# APPEAL SUMMARY

<b>Appeal ID:</b> 32105	<b>Project Address:</b> 2034 NW 27th Ave
<b>Hearing Date:</b> 1/31/24	<b>Appellant Name:</b> Tom Jaleski
<b>Case No.:</b> B-004	<b>Appellant Phone:</b> 971-238-5266
<b>Appeal Type:</b> Building	<b>Plans Examiner/Inspector:</b> John Cooley
<b>Project Type:</b> Commercial	<b>Stories:</b> 2 <b>Occupancy:</b> B, S-2 <b>Construction Type:</b> V-B
<b>Building/Business Name:</b> Redfox Commons JLR	<b>Fire Sprinklers:</b> Yes - NFPA 13 throughout
<b>Appeal Involves:</b> Alteration of an existing structure	<b>LUR or Permit Application No.:</b> 23-099605
<b>Plan Submitted Option:</b> pdf <a href="#">[File 1]</a> <a href="#">[File 2]</a>	<b>Proposed use:</b> Vehicle research lab

# REDFOX COMMONS - JLR TI

PERMIT SET - 10/31/2023

2. CODE ANALYSIS PLAN - LEVEL 2

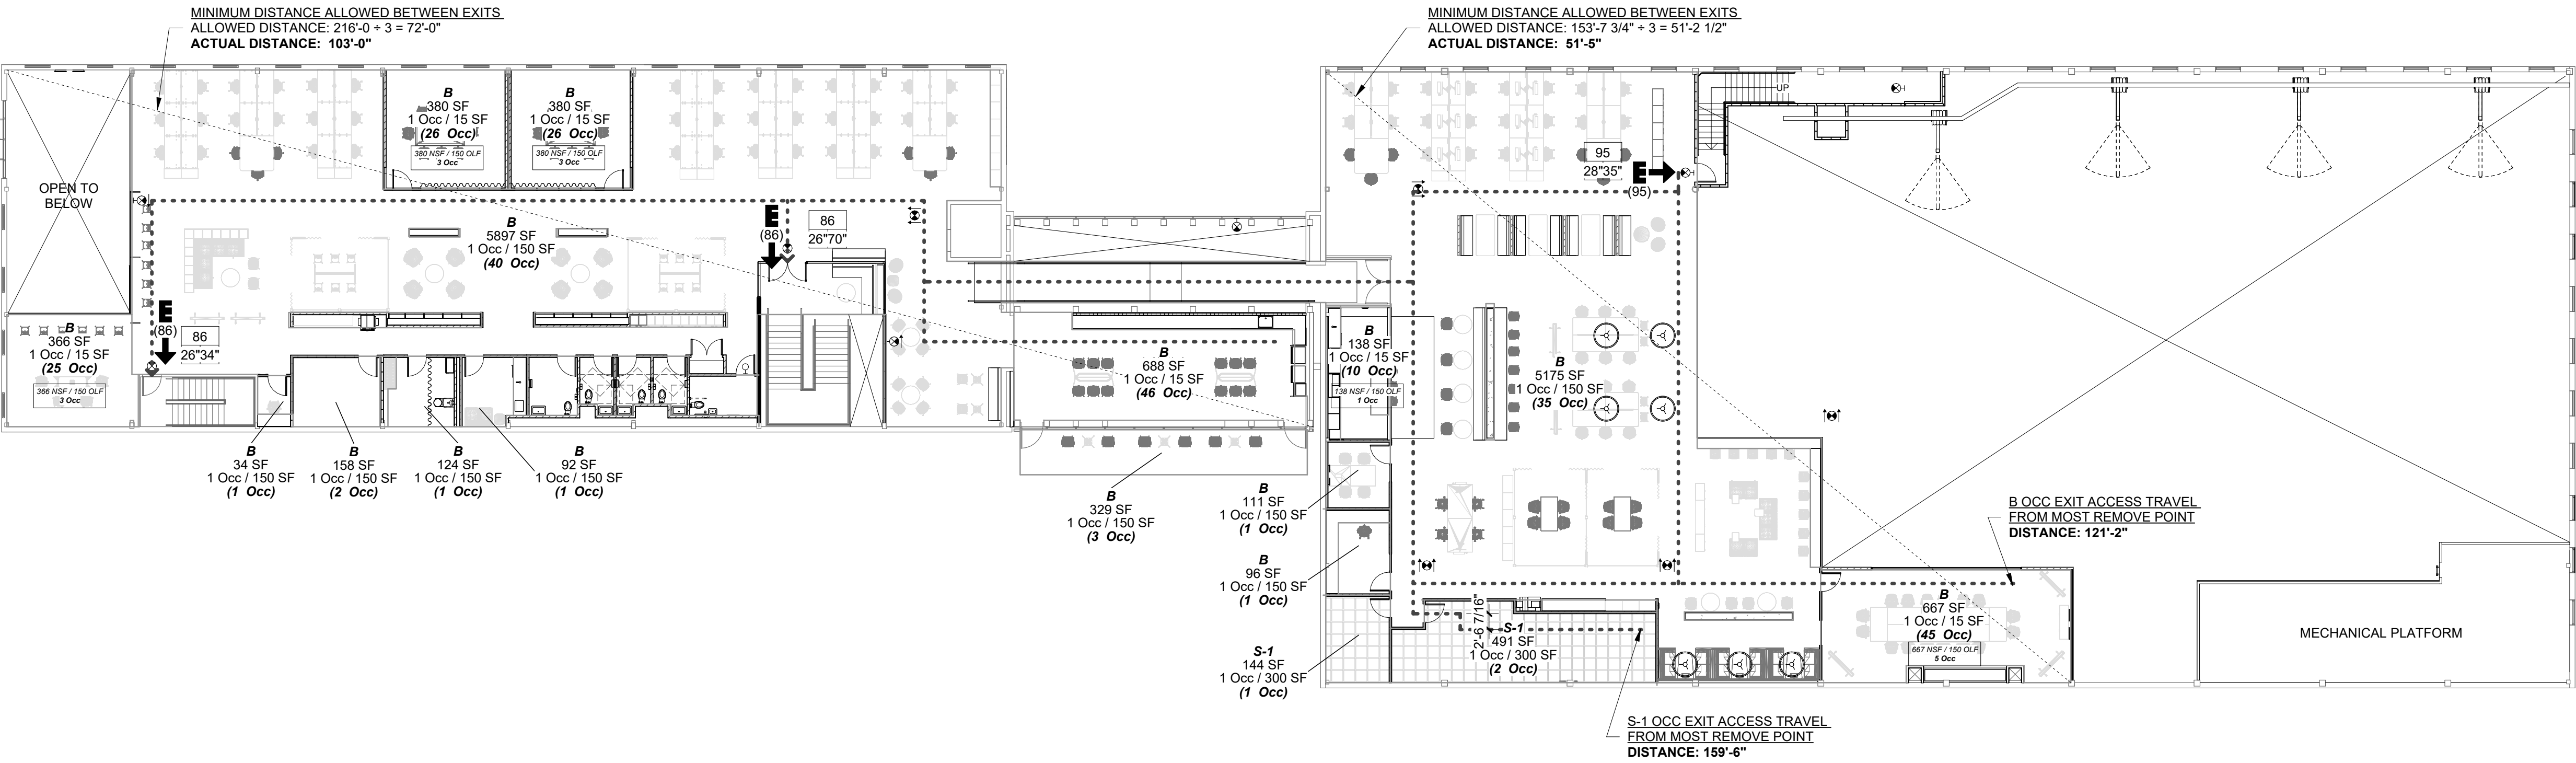
The proposed design is for the second floor break room and associated deck to be considered as partially non-simultaneous occupancy as the space is only accessible by stairs that restrict access to the second floor by card reader devices.

The proposed design is for a break room with a deck to be located on the second floor of the research lab. The second floor has 2 enclosed exit stairs, both with card readers on the doors to restrict access to employees only. Areas on the floor are sensitive knowledge-based information for the business and not accessible to the public.

The second floor break room and deck are for open to the second floor and for employees only. The proposed design is for the break room to be considered as outlined in the city code guide for offices for spaces adjacent to the office space per Code Guide 10/#10, item D.3, with an occupant load based on 1/150 s.f. and require only 1 exit, with less than 50 occupants.

The second floor of the proposed tenant improvement is a knowledge-based information sensitive area that can only be accessed through doors with card readers at the top of the stairs entering the second floor. The entire floor is a restricted access area. The break room and deck on the second floor is only accessed by the office space that must be entered through the card reader doors.

The location of the proposed break room is ideal in order to best serve all employees and it is bordered by an existing 2hr rated wall to the east and an existing ramp to the north.

The proposed design for the occupancy of the break room and deck, with the occupant load counted as office space that it is adjacent to and is associated with, is consistent with the Code Guide Item D.3, for small conference rooms that are adjacent to and directly associated with office spaces. Based on non-simultaneous occupancy with an occupant load based on 1/150 s.f. of the space, it provides equivalent protection for egress for the occupants who are familiar with the space.

**2) Allow breakroom and adjacent balcony to be considered as partially non-simultaneous use resulting in less than 50 cumulative occupants and requiring only one means of egress. Granted as proposed. "**
